THAMES VALLEY
SCIENCE PARK
PRIMARY INFRASTRUCTURE

NHM ACCESS ROAD
PROPOSED LEVELS AND
CONTOURS - SHEET 1

Scale	Date	Drawn	Checked
1:250 @ A1	APRIL 2024	AS	SM
Drawing No	HD065-401		Revision
			P5

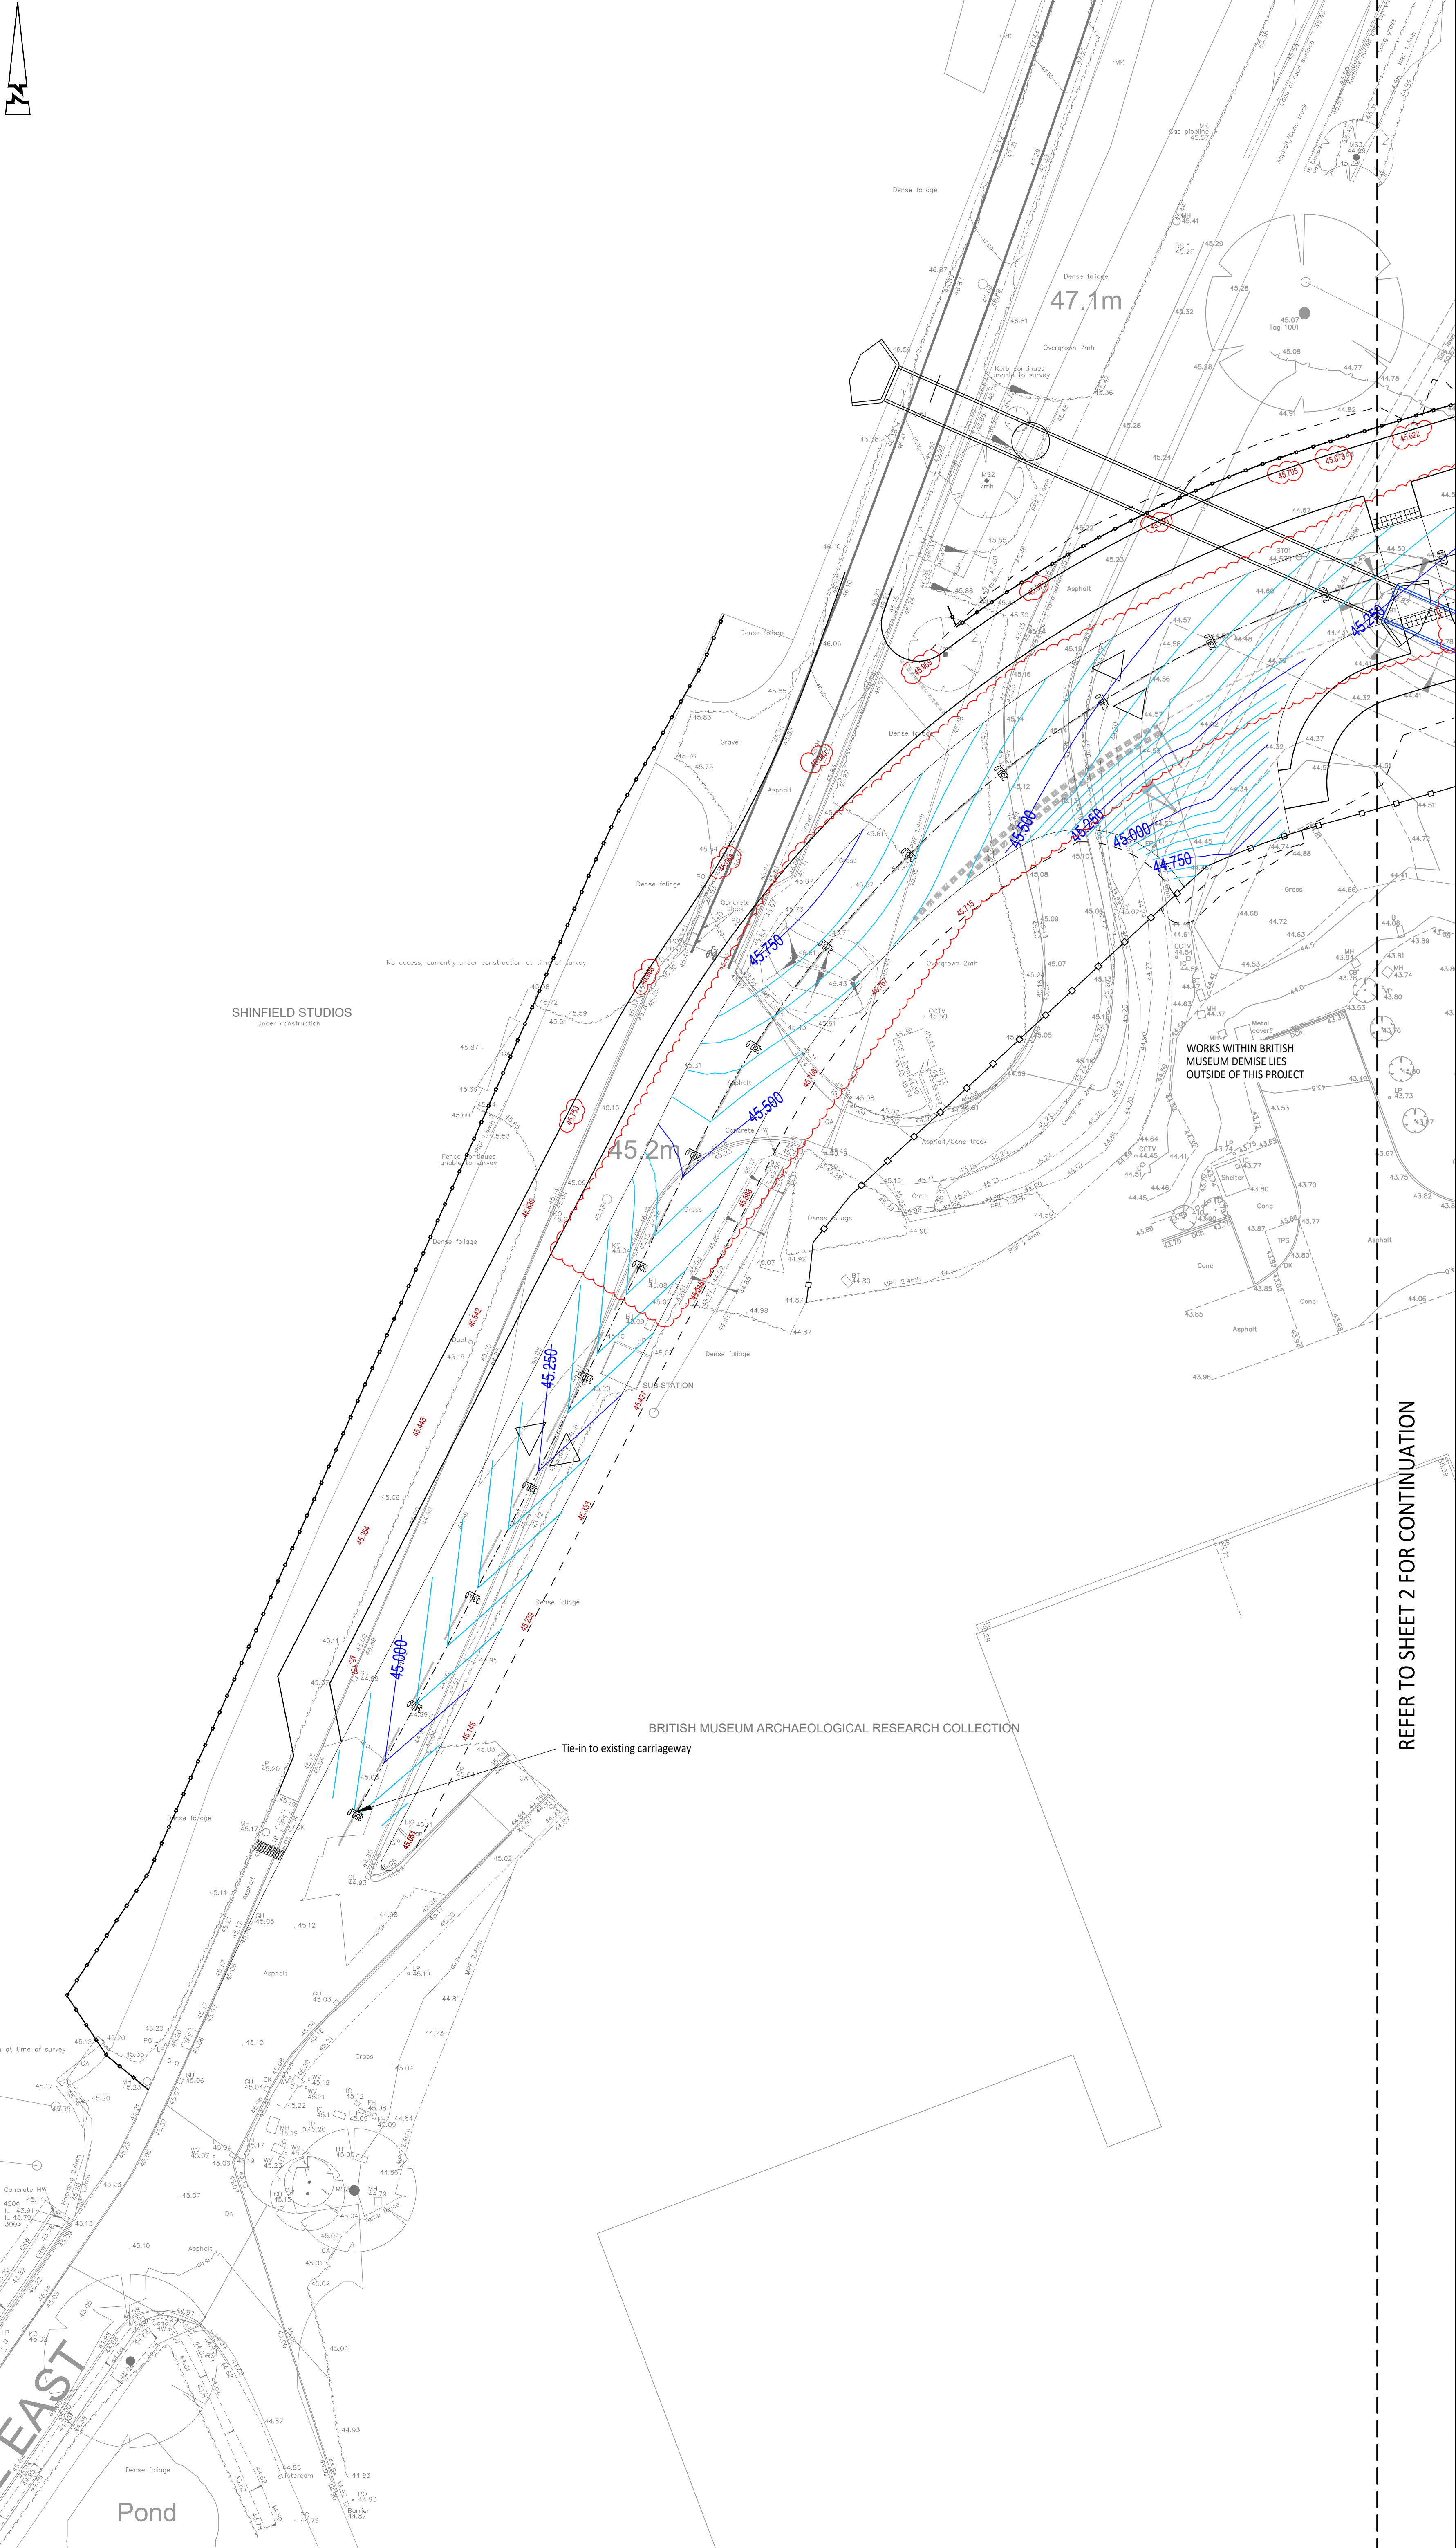
P5	06/24	Updated following WBC comments: crossfall adjusted around bend with back of footway levels and earthworks amended to suit and cycle lane to join carriageway removed with radius added to cycleway	SM	SM
P4	07/24	Fence line adjusted west side of Cutbush Lane	SM	SM
P3	07/24	BM access design updated	LC	SM
P2	05/24	Amended following design team review and BM access curtailed to demise boundary	LC	SM
P1	06/24	First issue	AS	SM
Rev	Date	Description	Drawn	Checked
